## 14.7 (2019/MINUTE NO 0046) PROPOSED STRUCTURE PLAN - LOT 176 (NO. 119) HAMMOND ROAD, SUCCESS

<b>Author(s)</b>	A Trosic
<b>Attachments</b>	1. Location Plan <a href="#">↓</a> 2. Structure Plan Map <a href="#">↓</a> 3. Schedule of Submissions <a href="#">↓</a>
<b>Location</b>	Lot 176 (No. 119) Hammond Road, Success
<b>Owner</b>	Dorothy Mary Guerini and Irene Anne Fruzynski
<b>Applicant</b>	Planning Solutions
<b>Application Reference</b>	110/193

**SCHEDULE OF SUBMISSIONS  
PROPOSED STRUCTURE PLAN – LOT 176 (NO. 119) HAMMOND ROAD, SUCCESS**

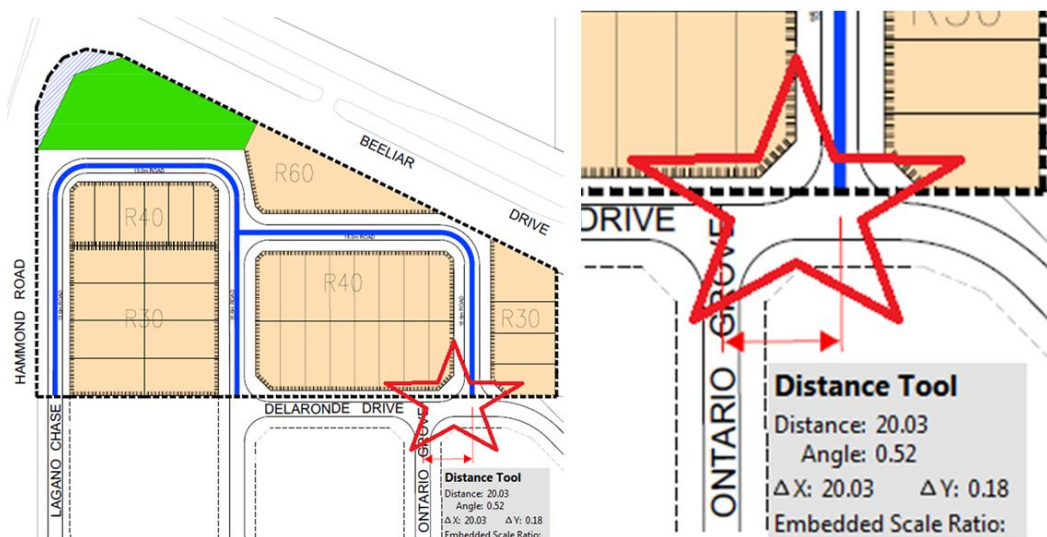
There has been concern raised by a resident under an objection in regards to traffic safety. Specifically the objection mentions that an adjacent (existing) property is positioned opposite a proposed (future) local road intersection. This is a traffic safety concern in the opinion of the objector.

The proposed streets are defined as “access streets” under the State Governments’ operational policy ‘Liveable Neighbourhoods’ (LN). Table 5 under element 2 of LN indicates a 20m (minimum) *‘junction spacing measured from road reserve centreline to terminating street pavements’* to be required. In accordance with this guidance (safety standard) within LN, the proposed road is considered to be acceptable from a road safety aspect as follows:

The above image has been edited to identify the subject area in question by the red star. As can be seen the junction spacing is measured at the minimum 20m. As such the proposed road network is considered to be safe as it is designed in accordance with LN (safety) principles. The concerns from this objection are therefore considered to have been addressed by the applicants’ proposal in accordance with best practice (LN).

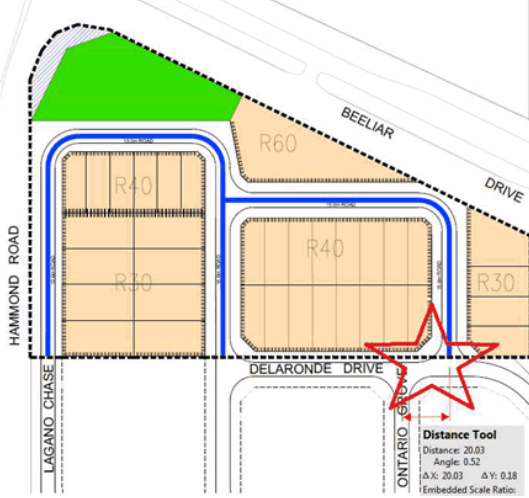
5	<p>Yulius Rendy Wardhana Usman 54 Delaronde Drive Success WA 6164</p>	<p><b>OBJECTION</b></p> <p>My name is Rendy and we live in 54 Delaronde (see pic below – submitters house identified in blue “our house”)</p>  <p>We bought and built our house here 2 years ago and we picked this lot because Murray said that the bush in front of our house was going to be bush forever, And We didn't expect the current proposal. Firstly we don't mind that you build the house(s) there but these are the things that we</p>	<p>Noted. In relation to Point 1 the distance of the centreline to centreline is 20m. This is shown below (in red) as follows;</p>

NO.	NAME/ADDRESS	SUBMISSION	RECOMMENDATION
		<p>didn't like it and disagree;</p> <ol style="list-style-type: none"> <li>1. If you see the picture, our house position is direct to the road which is basically dangerous for us because I heard so many accident happened in Australia, Some random cars drove into the house and we don't that happened to us.</li> <li>2. Why you didn't build a park in front of Our House makes better view and also good for environment.</li> <li>3. We pay extra when we build the house it's because if the bush but now the money that we spend seems for nothing</li> </ol> <p>Thank you for letting us put a comment; we hope you can consider this matter for Our family</p>	 <p>The proposed streets are defined as "access streets" under the State governments' operational policy 'Liveable Neighbourhoods' (LN). Table 5 under element 2 of LN has been extracted and inserted below. As can be seen from table 5 a 20m 'junction spacing measured from road reserve centreline to terminating street pavements'. As per LN the proposed road is considered to be acceptable from a road safety aspect.</p>

<p>The notion that a car could potentially/ hypothetically drive into your house is not considered to be increased in likelihood as a result of the proposed road design. Traffic accidents generally result from driving under the influence and/or speeding. Approval of this application does not necessarily imply an increased level of safety risk to residents. On this point objection point 1 is respectfully dismissed.</p> <p>It is understood that the request is for the park to be built in front of your house for better views (your views presumably) and also 'good for the environment'. Whilst this position may benefit your family the planning merits for such modifications are not based on planning rationale and are therefore not supported.</p> <p>It is understood that there is fondness for the existing bush and its environmental significance. However, the land is zoned for residential development and therefore residential development is permissible (subject to the approval of a Structure Plan) which would allow clearing of the existing vegetation on site.</p>	Street type	L/R stagger (to avoid overlapping right turns)	R/L stagger (To provide for left-turn deceleration lanes arterials and to avoid corner cutting on local streets)	<b>Local streets</b>			Laneway	NA	NA	Access street*	20 m	20 m
Street type	L/R stagger (to avoid overlapping right turns)	R/L stagger (To provide for left-turn deceleration lanes arterials and to avoid corner cutting on local streets)													
<b>Local streets</b>															
Laneway	NA	NA													
Access street*	20 m	20 m													
6	Tanesh Naidoo 60 Delaronde Drive, Success WA 6164	<p><b>OBJECTION</b></p> <p>We purchased on the perimeter of the estate so that we may enjoy the beautiful view of the trees and the tranquil sound of the birds. We had a choice of lots to choose from at the time, but opted for this lot, in spite of</p>	<p>Noted. Building to AS3959 Bushfire Constriction Standards is required under the Building Code of Australia where proposed Class 1, 2, 3 or 10a structures are</p>
